***EXPEDITED***  
**MONTGOMERY COUNTY HISTORIC PRESERVATION COMMISSION**  
**STAFF REPORT**

<b>Address:</b>	513 Philadelphia Ave., Takoma Park	<b>Meeting Date:</b>	4/20/2022
<b>Resource:</b>	Contributing Resource <b>Takoma Park Historic District</b>	<b>Report Date:</b>	4/13/2022
<b>Applicant:</b>	James Tate	<b>Public Notice:</b>	4/6/2022
<b>Review:</b>	HAWP	<b>Tax Credit:</b>	Partial
<b>Case No.:</b>	990356	<b>Staff:</b>	Dan Bruechert
<b>Proposal:</b>	Hardscape Alterations

21 MARCH 2022 (Rev. 07 APRIL)  
SCOPE OF WORK INDEX

# 1. Driveway Replacement

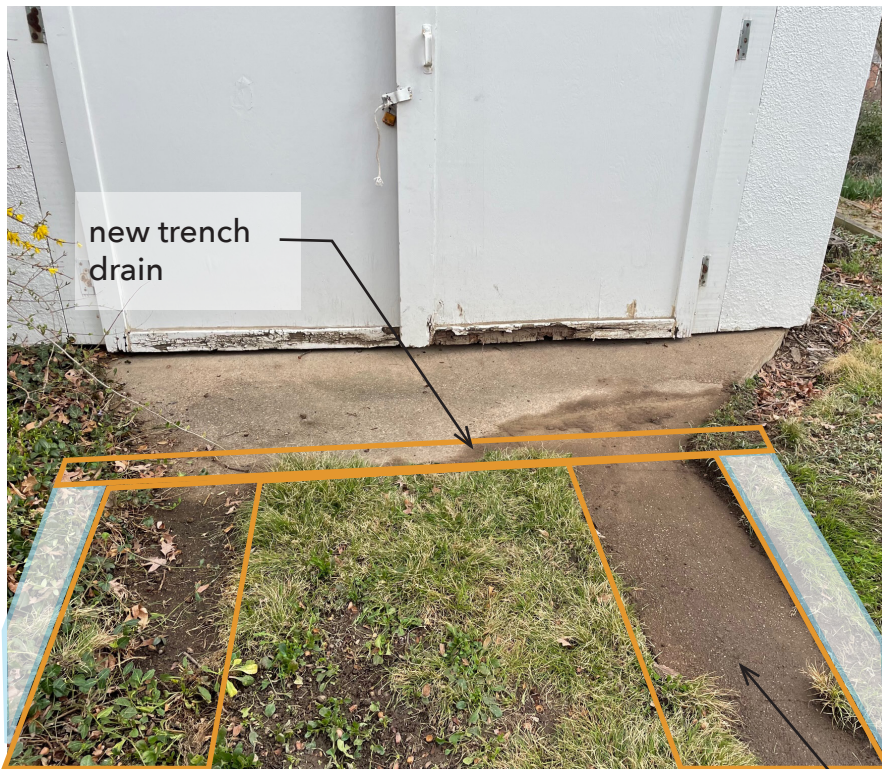
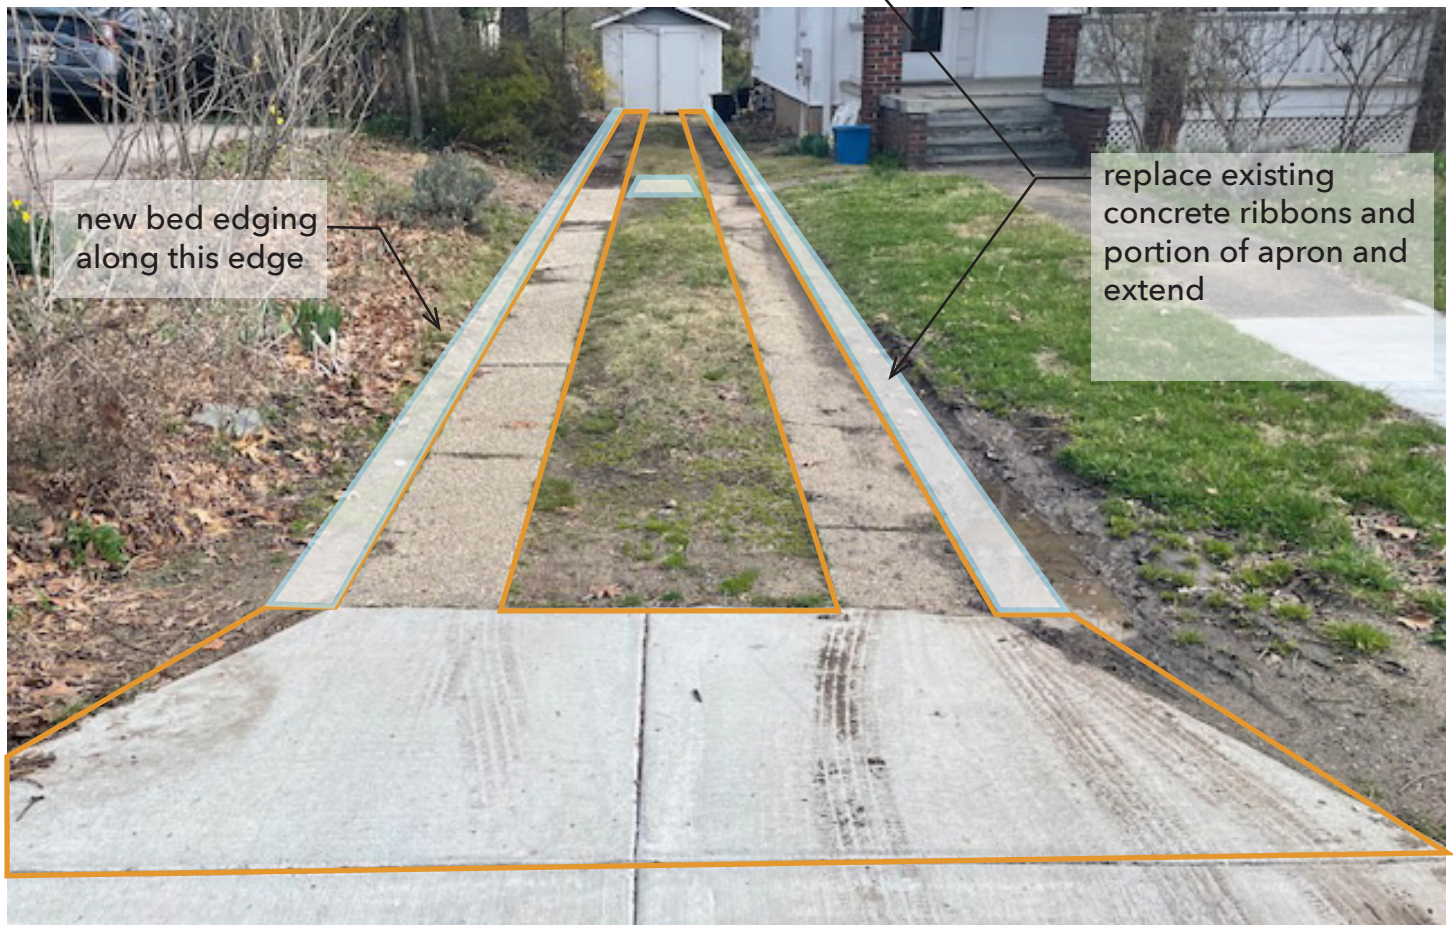
The existing driveway is a ribbon driveway with exposed aggregate concrete. Each ribbon is 20" (twenty inches wide) and suffers from cracks in the concrete and settling, particularly on the right side. The applicant proposes to remove the existing ribbons and apron, regrade the space between the front walk and the driveway, and install subterranean drains. The new ribbons and apron will be installed on new beds and will be 32" (thirty-two inches) wide and constructed out of exposed aggregate concrete. Staff finds retaining a ribbon driveway is preferable to a fully paved driveway and that the ribbons were constructed to accommodate smaller vehicles than are typical today. Staff additionally finds that the re-grading is a de minimis change that will not impact the visual character of the site, but will help improve drainage on the site and avoid the water pooling that is visible on the site today.

The last change the applicant proposes is to install two large pavers in the middle of the driveway that align with the walkways (front and rear) that connect the driveway to the house. Staff finds this change will not impact the character of the resource or surrounding district and recommends the HPC approve the HAWP.

Staff recommends that the Commission **approve** the HAWP application under the Criteria for Issuance in Chapter 24A-8(b)(1), (2) and (d); and the *Takoma Park Historic District Design Guidelines*; having found that the proposal will not substantially alter the exterior features of the historic resource and is compatible in character with the district and the purposes of Chapter 24A;
